Questions for AC/Pahl Hotel Steering Committee Meeting January 21, 2015 This will be emailed to relevant others

Subject: Development Proposal for the Pahl Tire Site

RE: North Central Group's Hotel Project on the Lamp House Block

Legistar #33109 (was #36335 on 1/14/15)

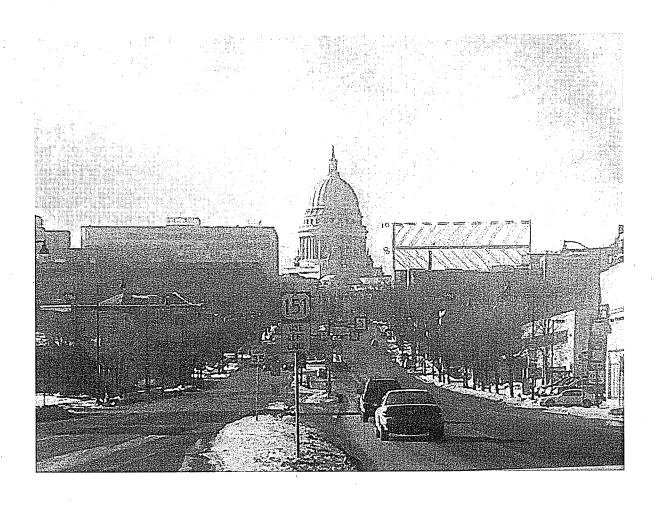
- c) The case regarding implications for The Lamp House are well presented and fully supportable.
- d) Have the required viewshed studies been provided by the developer (apologies if so)?
 ".....there are no negative impacts on the view shed as demonstrated by viewshed studies prepared by the applicant."

The following amateurish photo (below) is included to demonstrate the need for an illustrative and accurate study to show the impact of what is actually being proposed.
